ZONING CONDITIONS FOR THE MERRITT RESERVE

CONSTRUCTION DRAWINGS FOR MERRITT RESERVE

PROJECT NUMBER = CID-25-XX

COVER SHEET TITLE: G-001 SHEET NO.: G-001

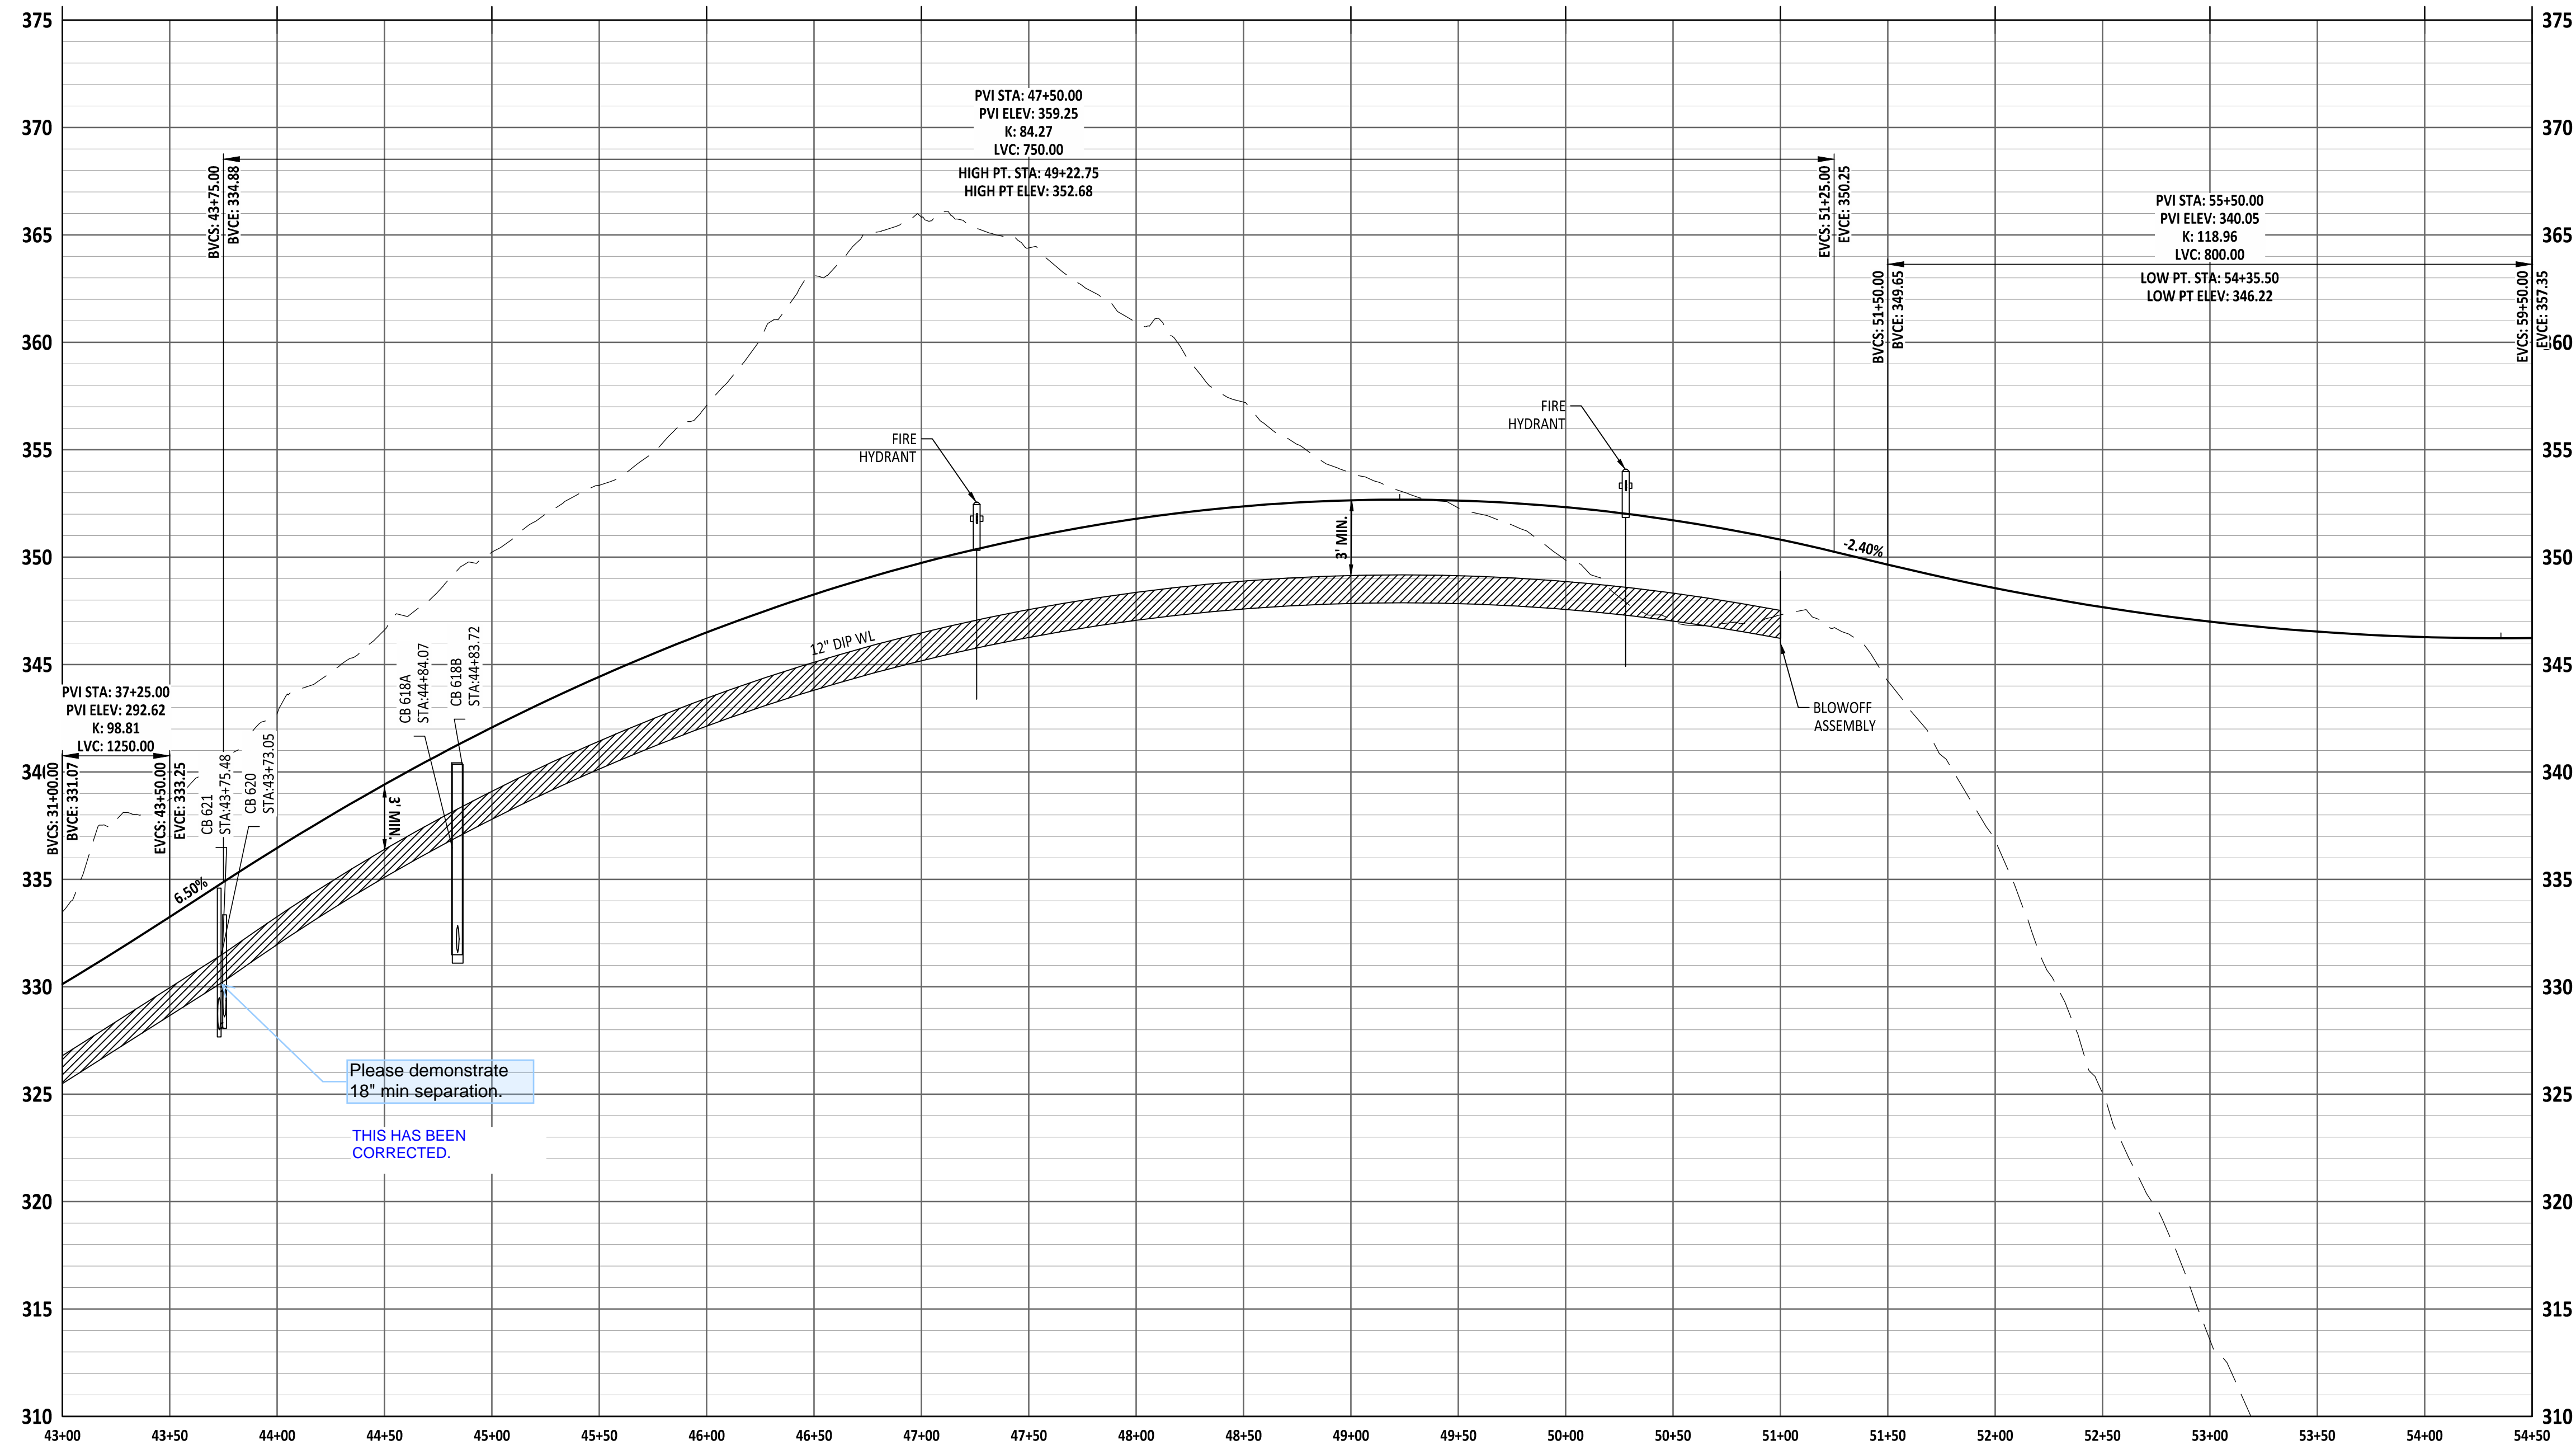
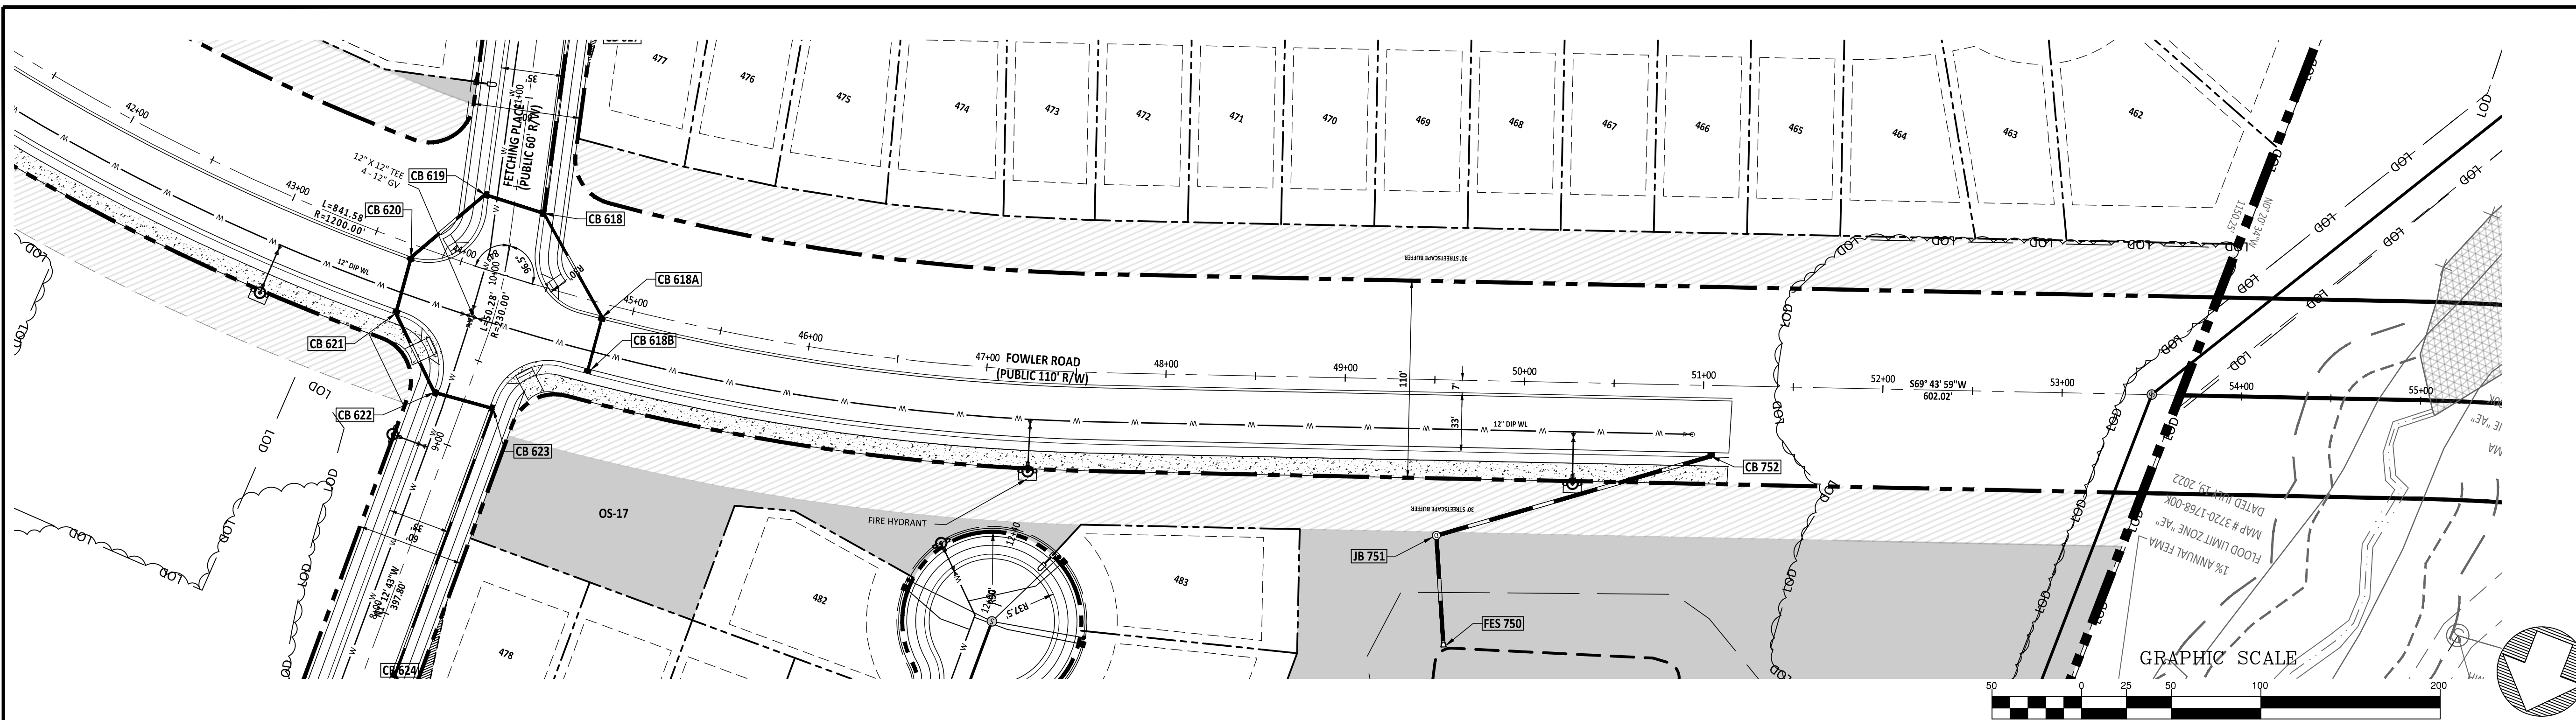
Once water and sewer design is complete, please email me for the public water and sewer permit numbers.

The public water and sewer permit blocks should be included on all the utility sheets and the plan/profile sheets.

Please use the most recent Attn: Contractors note. THIS HAS BEEN UPDATED

Please include the Raleigh public improvements table for merger towns on the cover sheet. THIS HAS BEEN UPDATED

Modifications are still in process to address some utility comments as well as value engineer some of the utilities.

The blocks have been added to all sheets that have utilities shown.
